**JOINT REGIONAL PLANNING PANEL  
(Sydney East Region)**

<b>JRPP No</b>	<b>2012SYE084</b>
<b>DA Number</b>	<b>DA-2012/311</b>
<b>Local Government Area</b>	<b>Willoughby</b>
<b>Proposed Development</b>	<b>Construction of 46 dwellings and the torrens title subdivision of the land into 46 lots on part of Stage 3 and Stage 4 of the Willoughby Market Gardens site.</b>
<b>Street Address</b>	<b>52 Mowbray Place, Mowbray Place, 17a, 19a, 21a Windsor Road, Windsor Road, 72, 74, 76 Eastern Valley Way, Eastern Valley Way, Willoughby NSW 2068</b>
<b>Applicant/Owner</b>	<b>PPK Willoughby Pty Limited</b>
<b>Number of Submissions</b>	<b>3</b>
<b>Recommendation</b>	<b>Approval with Conditions</b>
<b>Report by</b>	<b>Kate Drinan - Development Planner</b>

## Assessment Report and Recommendation

**PROPOSAL:** Willoughby Market Gardens site - construction of 46 dwellings and the torrens title subdivision of the land into 46 lots on part of Stage 3 and Stage 4 of the willoughby market gardens site.

#### **Lots 31 to 35**

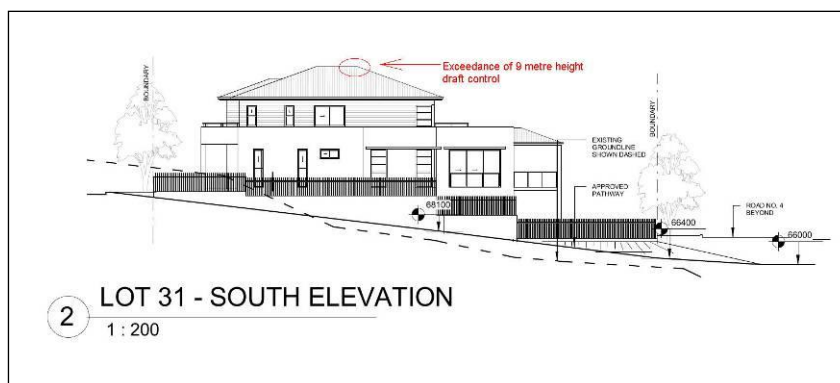
Lots 32 to 35 comply with the 9 metre height control of the Draft Willoughby Local Environmental Plan 2012. Lot 31 is not compliant. Notwithstanding, the area of non-compliance is setback a distance of approximately 12 metres from the park and the upper level has been recessed 4.9 metres from the wall of the level below giving the impression of 2 storeys as viewed from the public reserve as illustrated below. As viewed from the street, the dwelling will appear as 2 storeys. It is considered that the dwelling on lot 31 achieves the intent of Part 4.2.3 of the Design Guidelines which is to “emphasise the 2 storey scale” and is acceptable.

The southern elevation of the dwelling on Lot 31 is prominently located close to the entrance to the public reserve and park cycleway. It has a limited side setback being only 1 metre which will present unrelieved bulk to the public reserve and cycleway. The original application included a pathway along the southern boundary of Lot 31 which left no ability for landscaping which could help to screen the development. Subsequently, amended plans were received which relocated the pathway to the northern boundary leaving increased opportunity for landscaping on the southern side. Ideally, an increased side setback of the southern elevation of the dwelling on Lot 31 would be desirable however this dwelling has been identified as an adaptable dwelling and the increased side setbacks would make it difficult to achieve a compliant adaptable dwelling design. Given this, a condition is recommended requiring a 1.5 metre wide landscape strip on public land, along the southern boundary of Lot 31, to be provided and planted with native shrubs to a mature height of 3 to 5 metres to help soften the interface between the dwelling and the public reserve.

- (5) A 1.5 metre wide landscape strip on public land, along the southern boundary of Lot 31, is to be provided and planted with native shrubs which have a mature height of 3 to 5 metres. (Condition 3c)**

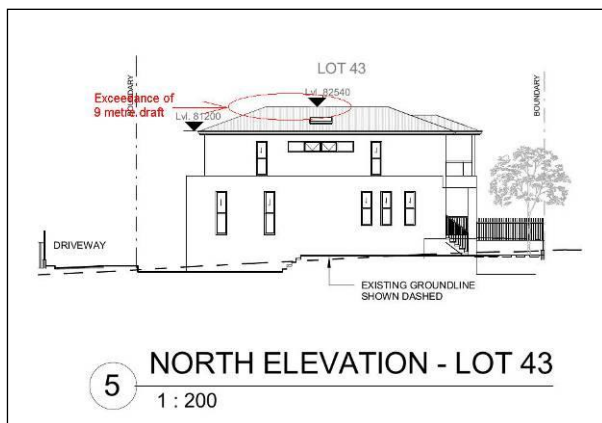
The dwellings on Lot 43-46 present as 2 storeys as viewed from the Windsor Road Public Reserve. As viewed from the private accessway, the dwellings on these lots will present as 3 storeys noting the fall of the land from west to east and the provision of garaging at the lower level. Having regard to the intent of the Design Guidelines, that being to emphasise a 2 storey scale, the dwellings are considered acceptable noting that from the public domain they are considered to meet this intent. Further, the dwellings are considered to suitably

respond to the fall of the land from north to south and the adjoining dwelling in Windsor Road as shown below.

The dwelling on Lot No. 43 exceeds the 9m height control of the Draft Willoughby Local Environmental Plan 2012 but it is noted that the exceedance occurs in the eastern portion of the dwelling, fronting the private accessway and as such will not be readily visible from the public domain as shown below.

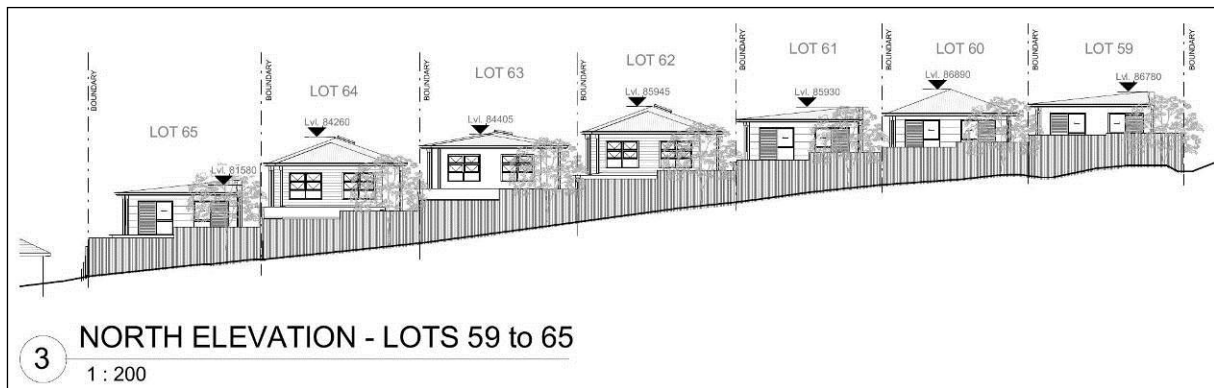
Given the fall of the land from north to south, the rear of the dwellings are 2 storeys, transitioning to 3 storeys towards the front (fronting Road No. 5). The dwellings are not considered to be consistent with the intent of the height controls of the Design Guidelines which is to "emphasise the 2 storey scale". However, it is considered that the dwellings are acceptable noting that the 3 storey element fronts an internal street and as such will not be readily visible from the public domain i.e. public reserve or Eastern Valley Way. The height of the dwellings as viewed from the neighbouring properties at the rear of the site (north) is considered acceptable as they will appear as 1 to 2 storey dwellings as shown below which is consistent with the Design Guidelines.

It is noted that the dwellings comply with the 9 metre height control of the Draft Willoughby Local Environmental Plan 2012.
